**Proposed Residential Development (Flat) with Shop and Services Use  
and Minor Relaxation of Plot Ratio and Building Height Restrictions  
at Lots 531 RP, 532 S.D. RP and 532 RP in DD 130 and  
the adjoining Government Land, Lam Tei, Tuen Mun  
(Planning Application No. A/TM-LTYY/502)**

**- Further Information No.1 -**

**Proposed Residential Development (Flat) with Shop and Services Uses  
with Minor Relaxation of Plot Ratio and Building Height Restrictions  
at Lots 531 RP, 532 S.D. RP and 532 RP in DD 130 and  
adjoining Government Land**

**Further Information No. 1**

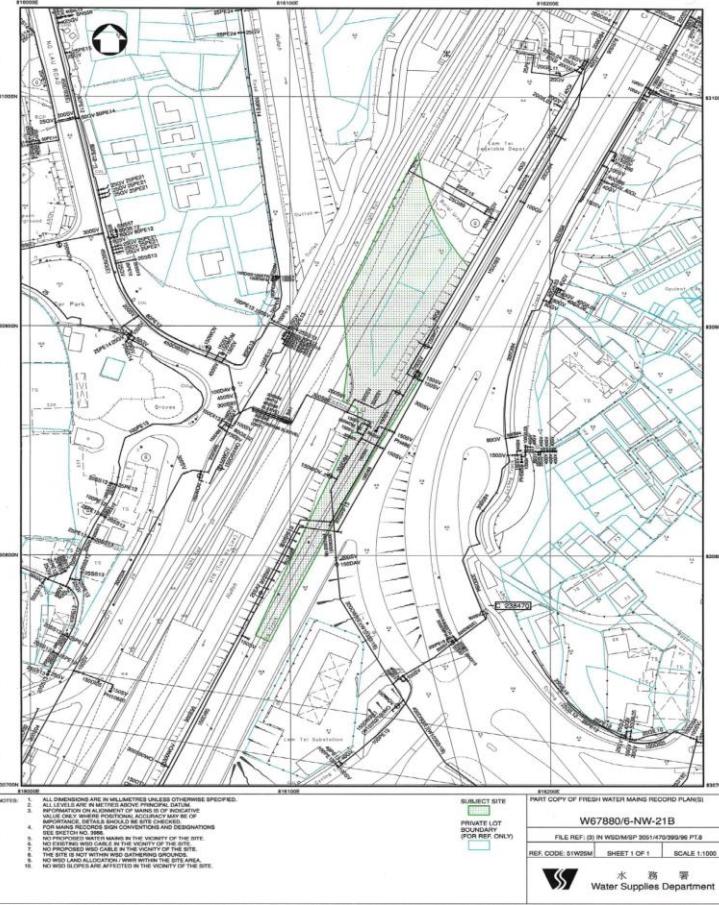
Comments	Summary & Response
<p>(i) Please demonstrate the queuing/waiting area for the car lifts is sufficient.</p> <p>(ii) Please advise the access routing to the bicycle parking area.</p>	<p>Queuing analysis has been carried out to demonstrate the queuing/waiting area for the car lifts is sufficient (<b>Appendix C</b> refers).</p> <p>Noted. The bicycle parking area has been relocated to the northern side of the Site and direct access to footpath has been provided as shown in <b>Figure 2.2 (Annex 1</b> refers).</p>
<p>10. Figure 2.3 -</p> <p>(i) Please demonstrate the queuing/waiting area for the car lifts is sufficient.</p> <p>(ii) Please indicate if there is sufficient area for the double deck car parking operation and demonstrate that the circulation of car park will not be affected during operation of the double deck system.</p>	<p>Queuing analysis has been carried out to demonstrate the queuing/waiting area for the car lifts is sufficient (<b>Appendix C</b> refers).</p> <p>Vehicles using the double-deck parking will park the vehicle on the parking platform like ordinary car park and the platform will be raised to the upper level. Therefore, the circulation of car park will not be affected during operation of the double-deck system. Below shows an existing double-deck parking system for reference:</p>

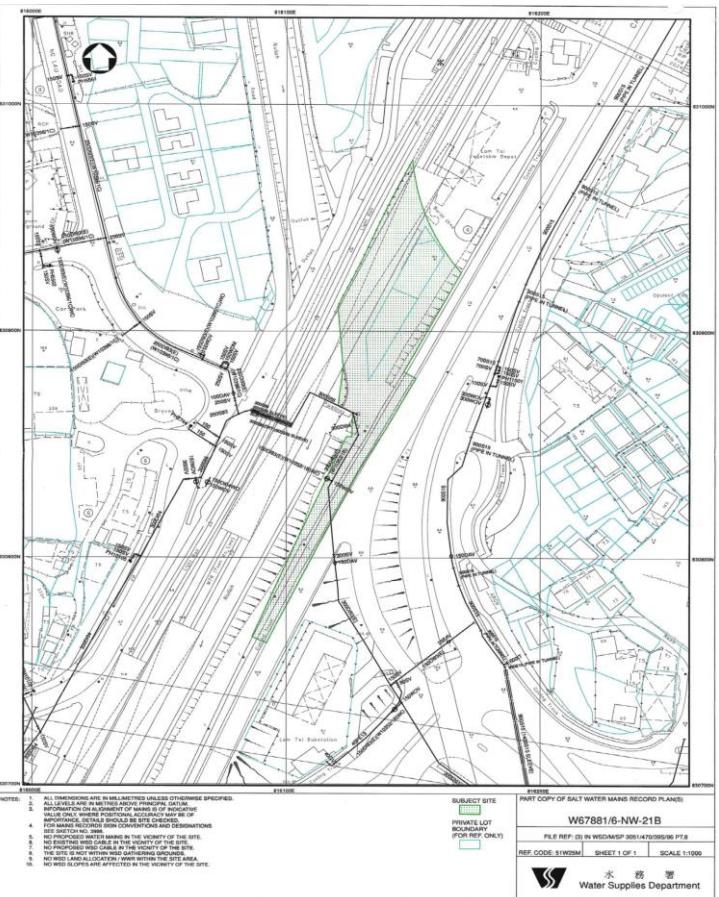
Comments	Summary & Response
11. Calculation sheets - Title of the calculation of J4 in year 2033 (design) is incorrect.	Noted, the calculation sheets have been revised accordingly ( <b>Annex 1</b> refers).
<p><b>Comments from the Water Supplies Department:</b> <b>(Contact Person: Mr Billy K B WONG, Tel: 2152 5779)</b></p> <ol style="list-style-type: none"><li data-bbox="193 605 1147 716">1. Existing water mains will be affected as shown on the plan. The cost of any necessary diversion shall be borne by the proposed development.</li><li data-bbox="193 747 1147 1002">2. In case it is not feasible to divert the affected water mains, a waterworks reserve within 1.5 metres from the center line of the water main shall be provided to WSD. No structure shall be built or materials stored within this waterworks reserve. Free access shall be available at all times for staff of the Director of Water Supplies or their contractor to carry out construction, inspection, operation, maintenance and repair works.</li><li data-bbox="193 1033 1147 1144">3. No trees or shrubs with penetrating roots may be planted within the Waterworks Reserve or in the vicinity of the water main shown on the plan.</li><li data-bbox="193 1176 1147 1287">4. Government shall not be liable to any damage whatsoever and howsoever caused arising from burst or leakage of the public water mains within and in close vicinity of the site.</li></ol>	Noted.  Noted.  Noted.  Noted.
